Number	Questions	Question Reference	Answers
Terminal 3				
T3.U.8D.D	1	Please confirm the area highlighted in yellow is a service corridor	 <p>Space: T3.U.8F.C Total: 1,273 s.f.</p> <p>Spill out zone Space: T3.U.8F.C Total: 598 s.f.</p>	The Architect of Record & Tenant will be responsible for verifying the highlighted element in the field. However, the highlighted element appears to be part of the airport building service corridor.
T3.U.8D.D	2	Can we fasten/bolt any structures/furniture to the spill-out zone flooring?		The spill-out zone may be used for temporary merchandise displays, customer queuing, and temporary seating. No permanent alterations or fixing of furniture is allowed. Refer to the CDA O'Hare Concessionaire Design Guidelines for spill-out layout options sheet #ii.
T3.U.8D.D	3	The TDC denotes a dashed line within the LOD. What does the dashed line mean? (circled in green)	 <p>Space: T3.U.8F.C Total: 1,273 s.f.</p> <p>Spill out zone Space: T3.U.8F.C Total: 598 s.f.</p>	The dashed line is the existing soffit.

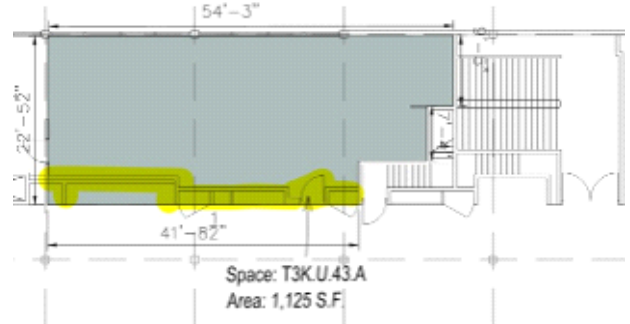
T3.U.8.AA.4	19	Please indicate what the space highlighted in green is used for.	 <p>The diagram is identical to the one for question 18, but the green highlighted area is more prominent. It shows a rectangular area within the spill out zone. Labels include: 'Space: T3.U.8.AA.4 Total: 2,012 s.f.', 'Spill out zone Space: T3.U.8.AA.4 Total: 449 s.f.', and dimensions like '12'-3"', '8'-5"', '10'-5"', '45'-5"', and '24'-5"'. A yellow highlighted area is also visible on the left side of the plan.</p>	This airport utility space is strictly for airport use only and does not fall within the boundaries of the LOD.

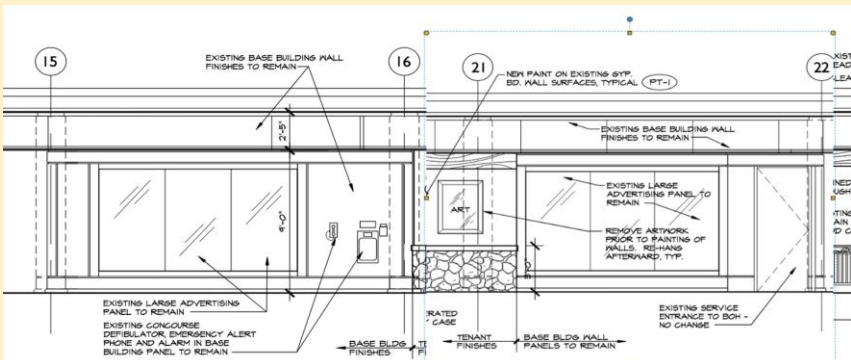
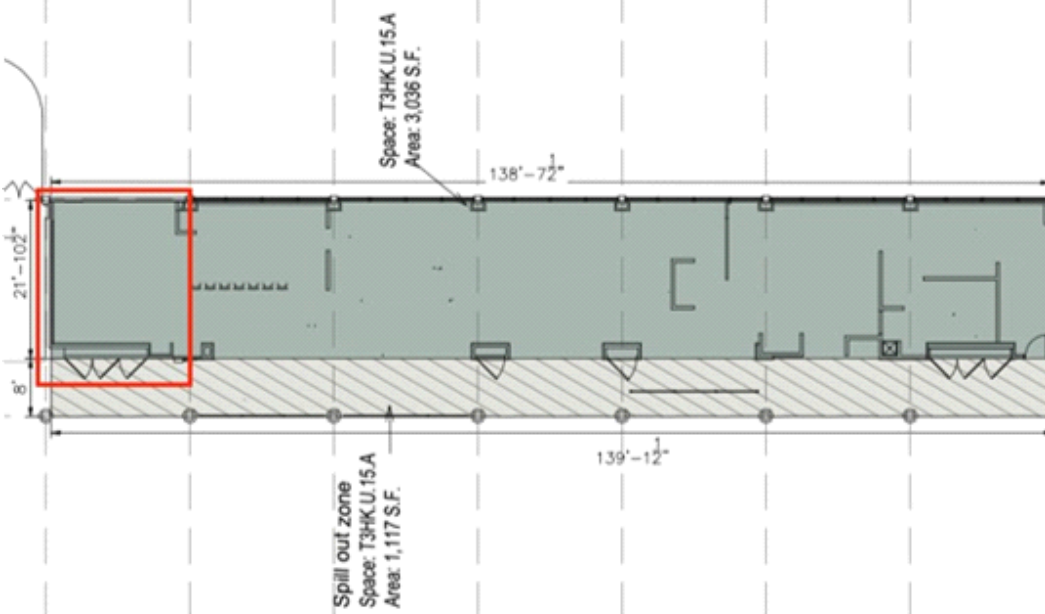
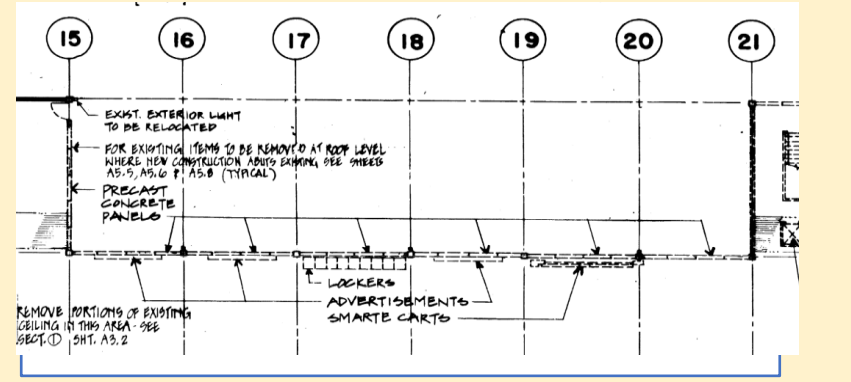
T3K.U.73	48	Please confirm extent of demo associated with restroom removal - LOD & Design Guideline Drawings show different extents of existing vs possible demo		An airport-funded capital project will support modifications and upgrades to the Concourse K Food Hall and adjacent areas to implement new white-box commercial space. The final square footage of the food hall will depend upon the capital project design development with the final layout recommendation made by the project architect in coordination with the CDA and concessionaire.
T3K.U.73	49	In preliminary artist renderings of the airport there appears to be hanging art installations in this space. Is the tenant allowed to suspend from the base building ceiling/structure in this location?		The CDA will review all design decisions during the design review process.

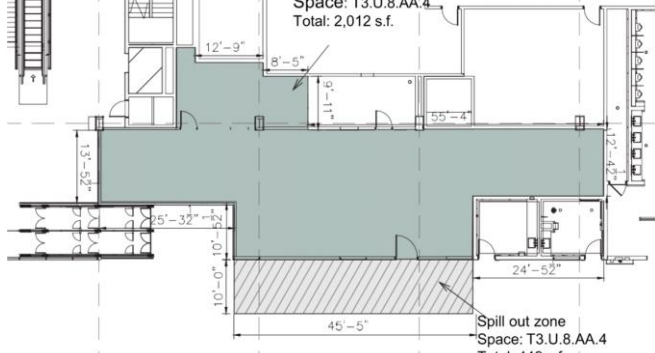
Number	Questions	Question Reference	Answers
T3HK.U.27.A	92	<p>Are the squares highlighted in red structural? Or can these be demolished? They are currently shown as brick-look columns (see reference image).</p>		<p>The Architect of Record & Tenant will be responsible for verifying the highlighted element in the field. However, the highlighted element does not appear to be a structural element. The CDA will review all design decisions during the design review process.</p>
T3G.U.29.B	93	<p>The area highlighted in yellow looks to be a solid wall and it is uncertain if the finish shown aligns with the existing concept. Is this airport base build wall and the cladding should remain, or can we refinish the wall. Secondly, if it is not airport base build wall then we will assume we can remove & relocate the door if needed. Please advise and refer to image below</p>		<p>The extent of development is to be within the boundaries defined by the LOD. The CDA will review all design decisions during the design review process.</p>   <p>AS BUILT- SHEET# 428,ID#81238</p>

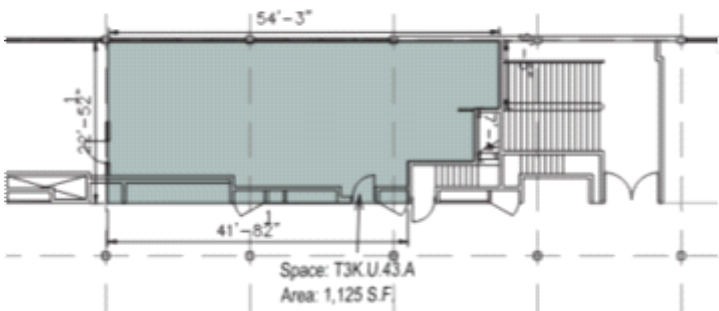
T3.G.U.61.A	108	Space ID T3.G.U.61.A FB3 / A: Can the CDA please confirm whether or not the existing exterior glazing is not insulated, nor is it tempered glass? This makes it expensive to replace when broken. Can the CDA please confirm who would be responsible for that expense?	 <p>T3G.U.61.A F & B • 2 x OSR • 1 x Bar • Seating/Queuing TOTAL 5,580 sq ft PKG: FB3</p>	The extent of development responsibility is to be within the boundaries defined by the LOD. Tenant to keep a minimum clearance of 18" for access to curtain wall. CDA would review responsibility of the broken glass at time of incident. Please refer to the O'Hare Concessionaire Design Guidelines General Design Guidelines 1-39 for further information. The CDA will review all design decisions during the design review process.
